ADDENDUM NO. 1

FEBRUARY 11, 2026

JACKSON COUNTY FAIRGROUNDS NEW EQUIPMENT STORAGE BLDG JACKSON COUNTY BOARD OF SUPERVISORS PASCAGOULA, MISSISSIPPI

C100R

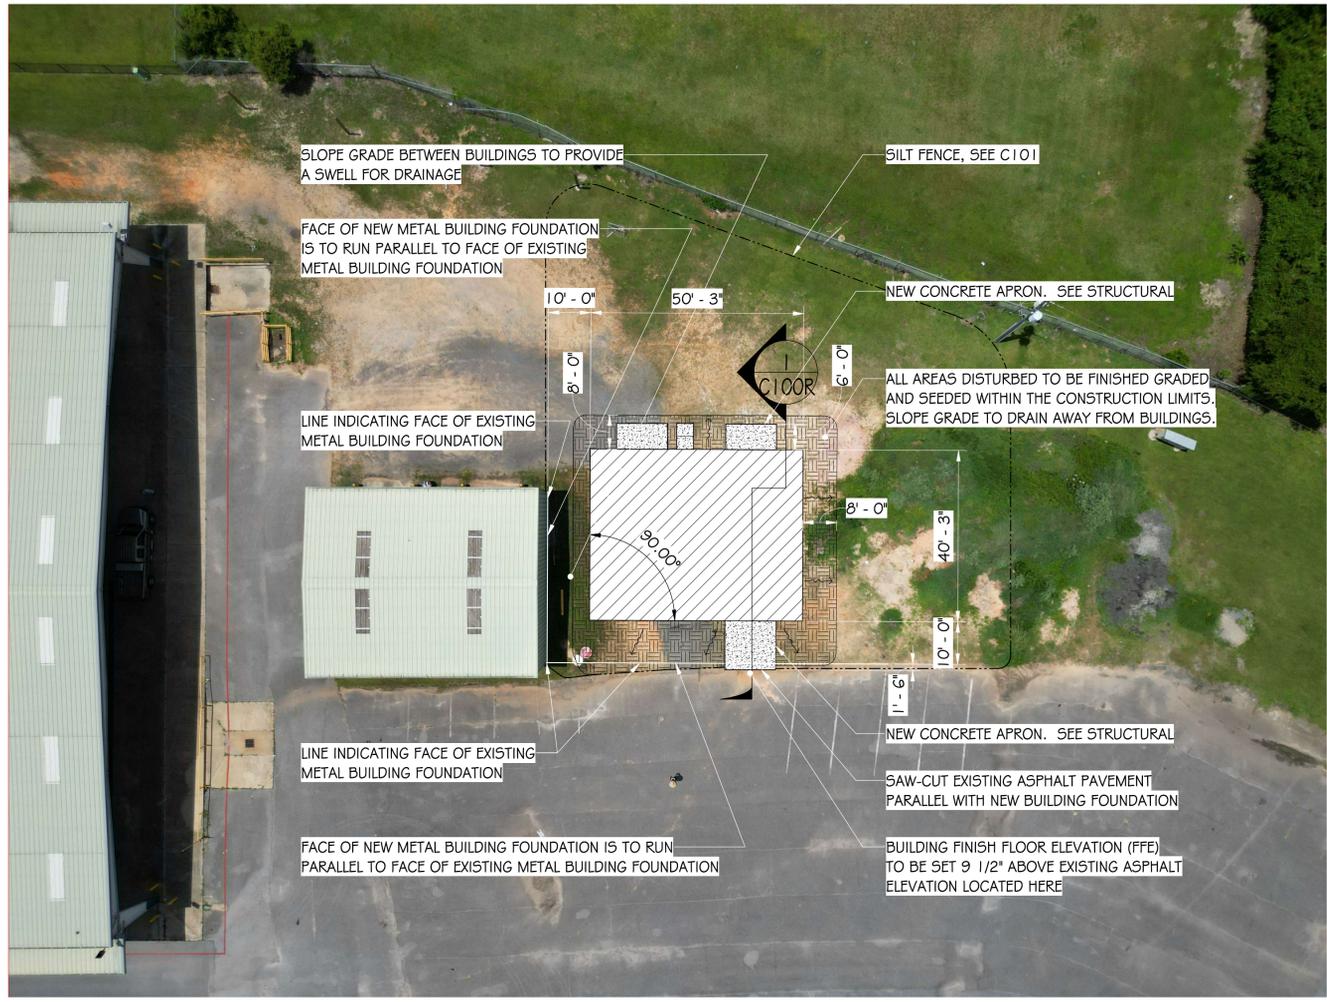
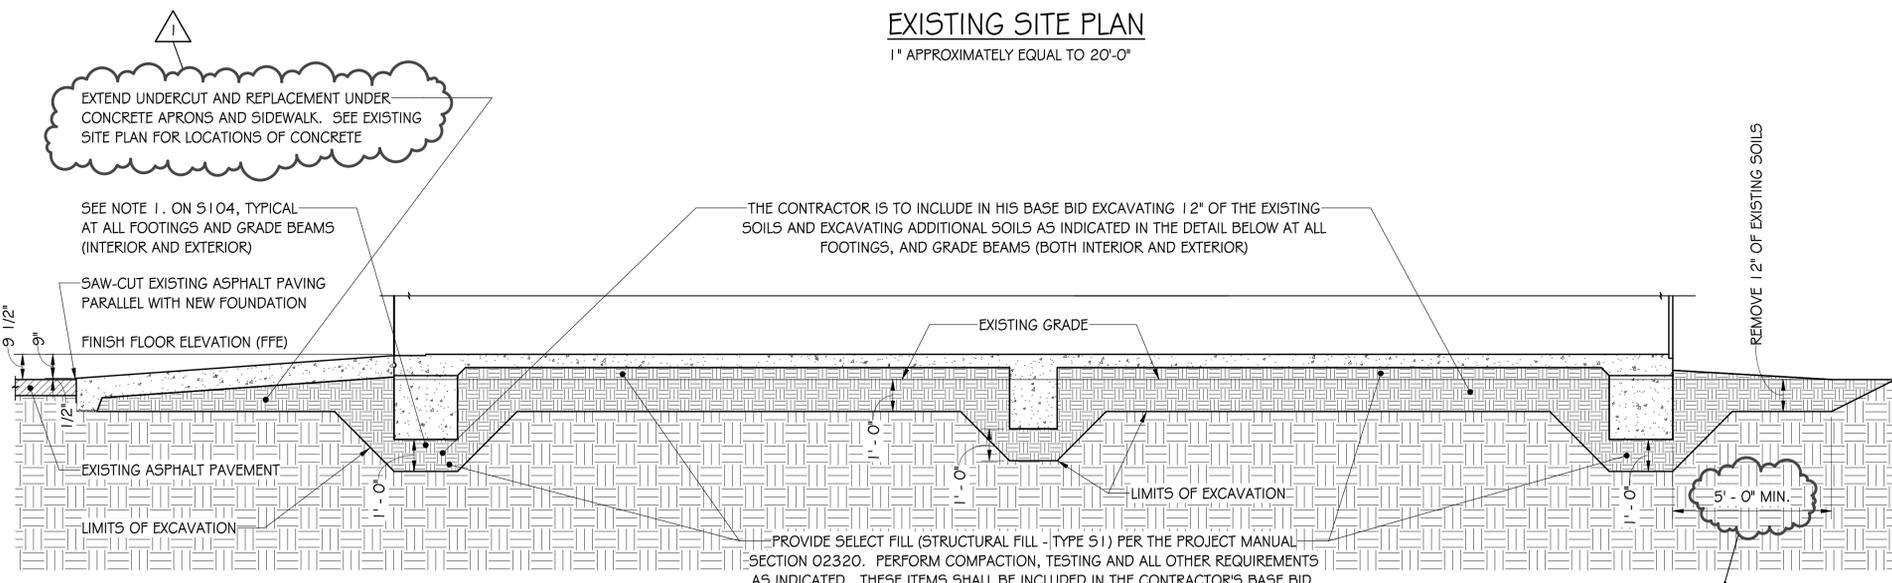
1. Sheet C100 – EXISTING SITE & EROSION CONTROL PLAN

- a. Delete sheet in its entirety and replace with attached sheet C100R – EXISTING SITE & EROSION CONTROL PLAN; changes are clouded and labeled with an addendum mark. Update the Sheet Index accordingly.
2. Sheet S102 – FIRST FLOOR PLAN – STORAGE BLDG
 - a. Delete sheet in its entirety and replace with attached sheet S102R – FIRST FLOOR PLAN – STORAGE BLDG; changes are clouded and labeled with an addendum mark. Update the Sheet Index accordingly.

Question: Is the undercut and replacement to be extended to 5' outside the perimeter of the building slab?

Answer: Yes. The undercut and replacement should be extended to a minimum of 5' outside the perimeter of the building slab, except where we have concrete approach slabs and sidewalk. See Attached Revised Sheet C100R.

S102R

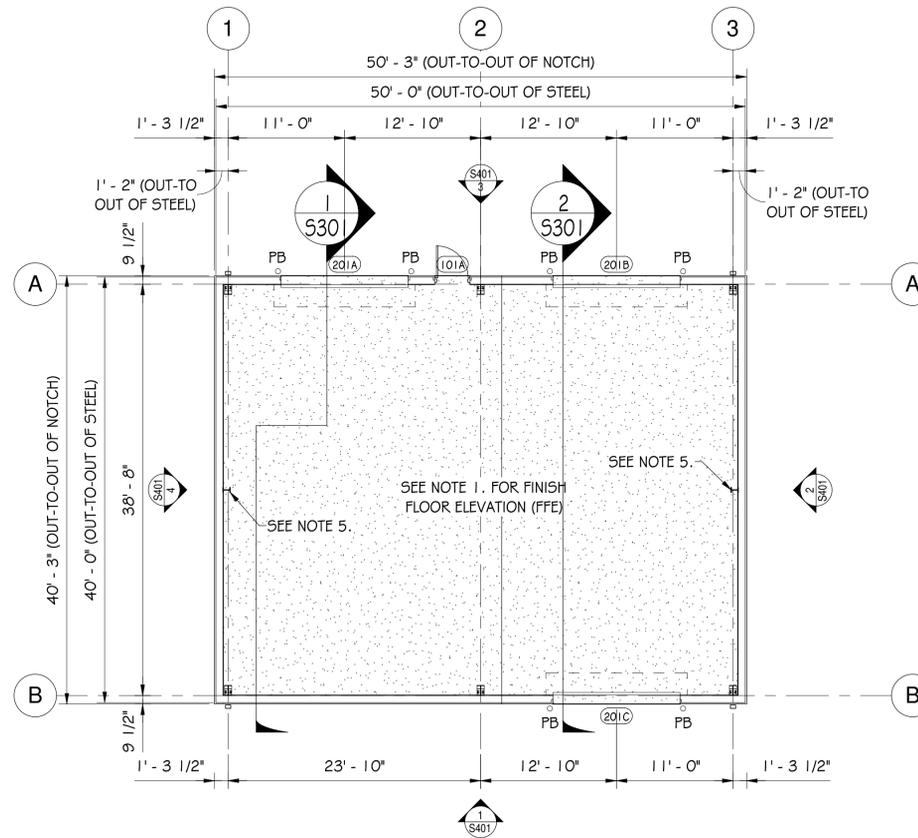
1. Question: Is there an estimated value or budget for this project?
Answer: The Engineer's Estimate is indicated on the Pre-Bid Meeting Minutes.
2. Question: The project duration is 150 Calendar Days (120 to substantial). The current lead time to procure PEMB Shop Drawings & Calculations is 5 to 6 weeks (35 to 42 days) and then fabrication and delivery is averaging about 10 weeks (70 days). That is 105 to 112 days, and that is not counting erection, door, electric or finish installation. Can the project duration be extended?
Answer: The Project duration is as indicated in the Project Manual.
3. Question: The door notes call for a Wayne Dalton 790 CW with a Miami Dade wind load. The WD 790 is not available with a Miami Dade wind load. (see attached wind

load report). Please clarify if they want the WD 790 with attached wind load rating or a coiling steel door with Miami Dade wind load.

Answer: See attached Sheet S102R – First Floor Plan – Storage Bldg for revised roll-up door model.

1. WALK-IN DOOR(S) SHALL BE PREMIER STEEL DOORS AND FRAME SERIES S20-4 (1 3/4" POLYSTYRENE CORE) OR APPROVED EQUIVALENT. SEE PROJECT SPECIFICATIONS SECTION 13342 - METAL BUILDING SYSTEMS FOR ADDITIONAL REQUIREMENTS.
2. ROLL-UP DOOR(S) SHALL BE WAYNE DALTON MODEL D5-350 OR APPROVED EQUIVALENT.
 - A. ROLL-UP DOOR PERFORMANCE REQUIREMENTS:
 1. DESIGN WIND LOADS: UNIFORM COMPONENT AND CLADDING PRESSURES (ASD) INDICATED ON THE DRAWINGS (SHEET S100B).
 2. TESTING: ACCORDING TO ASTM E 330 OR DASMA 108 FOR GARAGE DOORS AND MEETING THE ACCEPTANCE CRITERIA OF DASMA 108.
 3. DEFLECTION LIMITS: DESIGN OVERHEAD COILING DOORS TO WITHSTAND DESIGN WIND LOAD WITHOUT EVIDENCING PERMANENT DEFORMATION OR DISENGAGEMENT OF DOOR COMPONENTS.
 4. SEE PROJECT SPECIFICATIONS SECTION 13342 - METAL BUILDING SYSTEMS FOR ADDITIONAL REQUIREMENTS.
